GRANDWOOD RANCH PRELIMINARY PLAN

S $\frac{1}{2}$ OF THE N $\frac{1}{2}$ OF SECTION 19, TOWNSHIP 11 SOUTH, RANGE 66 WEST, EL PASO COUNTY, CO

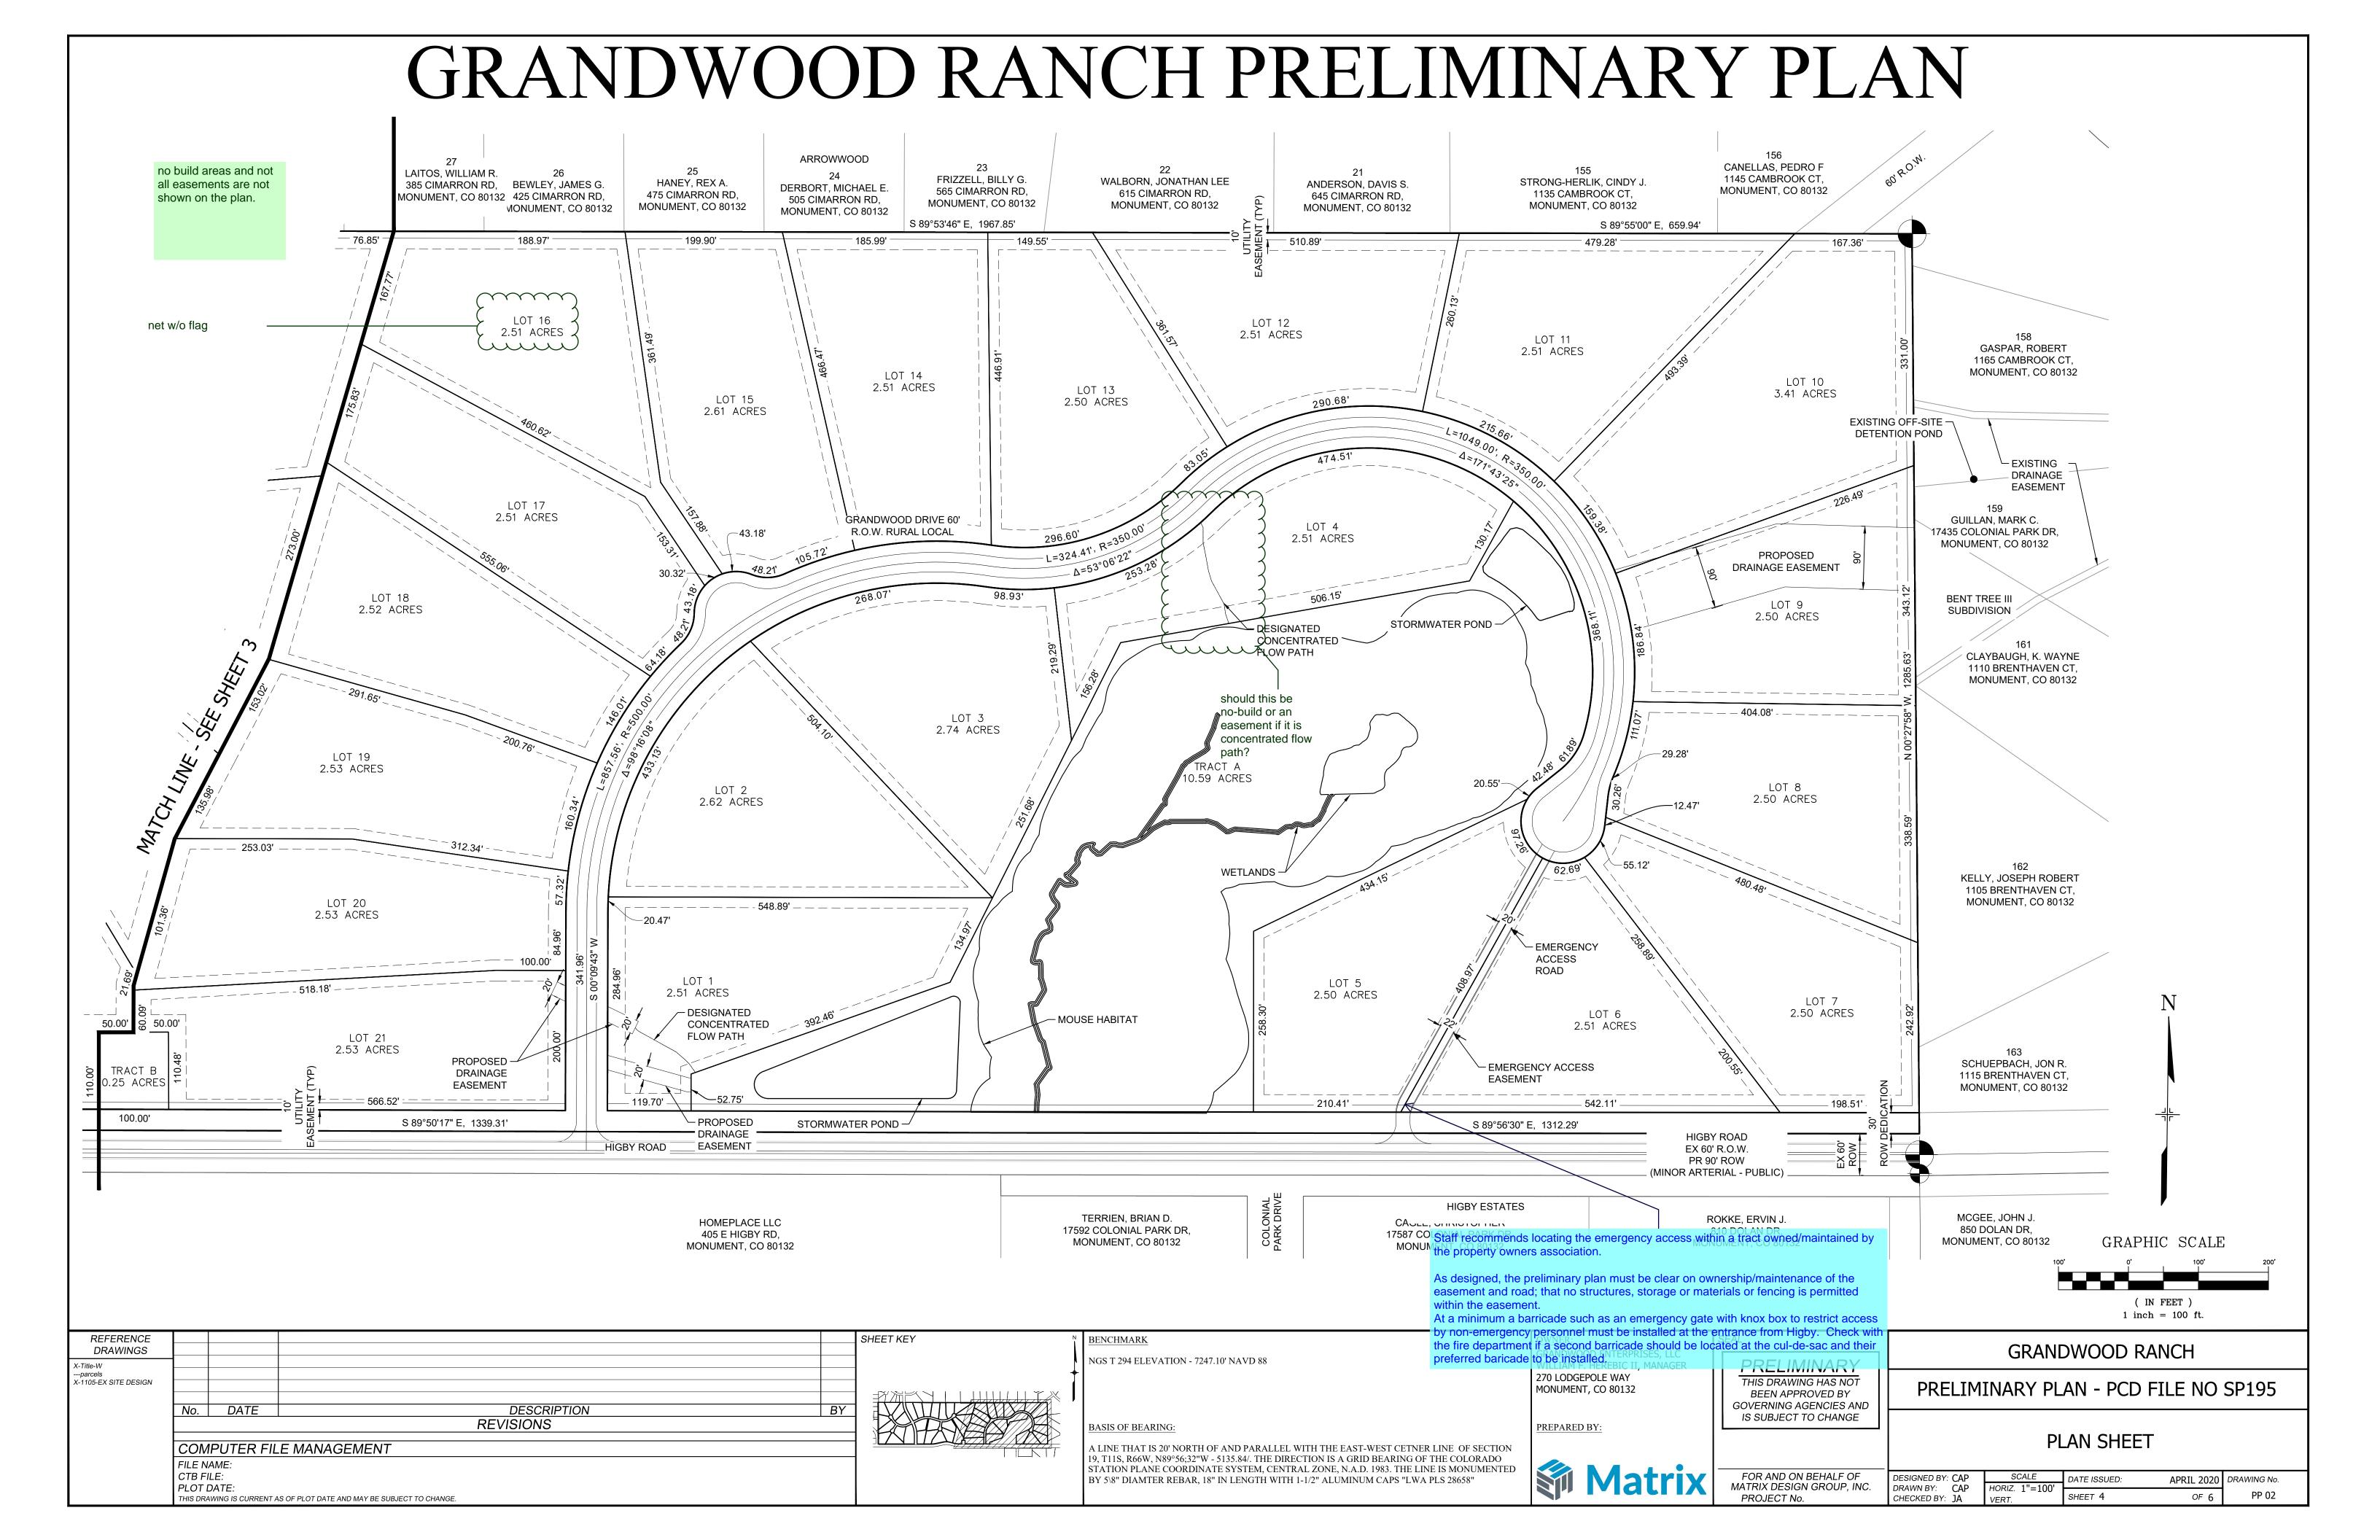
Provide a typical cross section for the offsite section of Furrow Rd at
